DOCUMENT CHANGE REQUEST

DCR number 316	Changes required for: N/A	Originator: Olivier Masson Chief
Date: 2007/02/01	Date sent: 2007/02/01	Organisation: CNES
Status: IMPLEMENTED

Title:	Contacts Power Crimp-Type and Solder Type for 3401/001 and 3401/002 Connectors		
Number:	3401/040	Issue:	3

FIGURE 2(c) - PROTRUSION AND RECESS

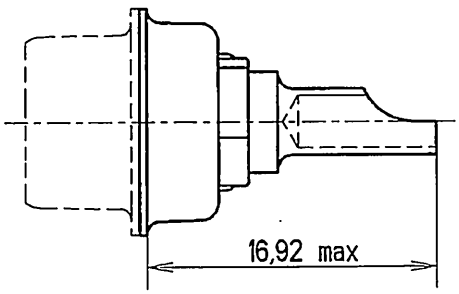
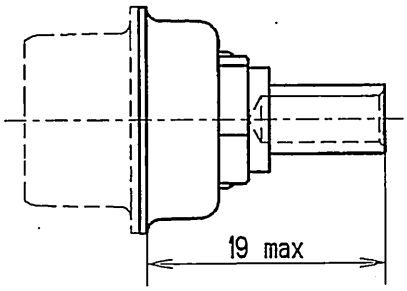
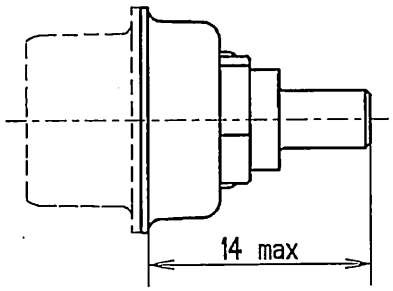
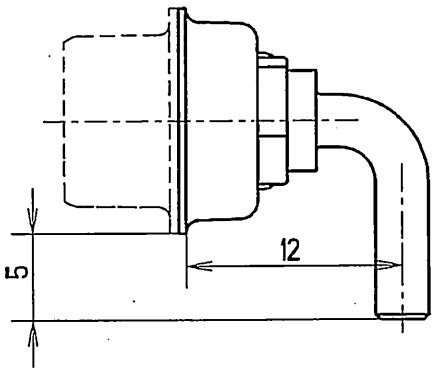
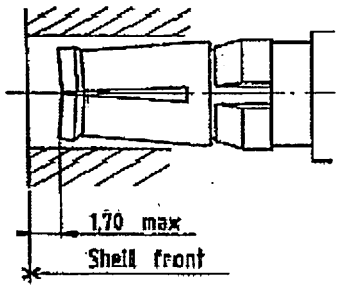
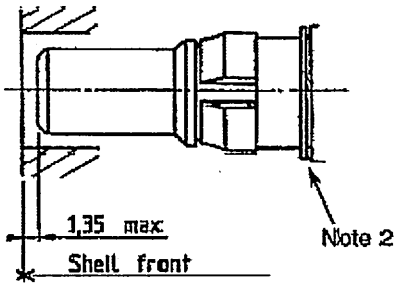
Attachments:
3401040_p13.pdf, 3401040_p10.pdf, 3401040_p12.pdf, null
Modifications:
and the following:) Page 1, Spec Title: amend to include " ... AND PCB-TYPE FOR ..." 2) Page 6 & 11, Para 1.1 & 2. Amend titles of 3401/001 & 3401/002 to reflect the latest titles. 3) Page 6, Table 1(a). Manufacturer to advised the maximum weights for new Variants 13 to 16. 4) New Figure 2(c). Figure should be in the same format as used in Fig 2(a) & 2(b) i.e. Dimension letter & Table format. Title should be: "FIGURE 2(c) - STRAIGHT AND 90deg PCB TYPE" 5) Page 10, Fig 2(c) should be renumbered: "FIGURE 2(d)"
Approval signature:
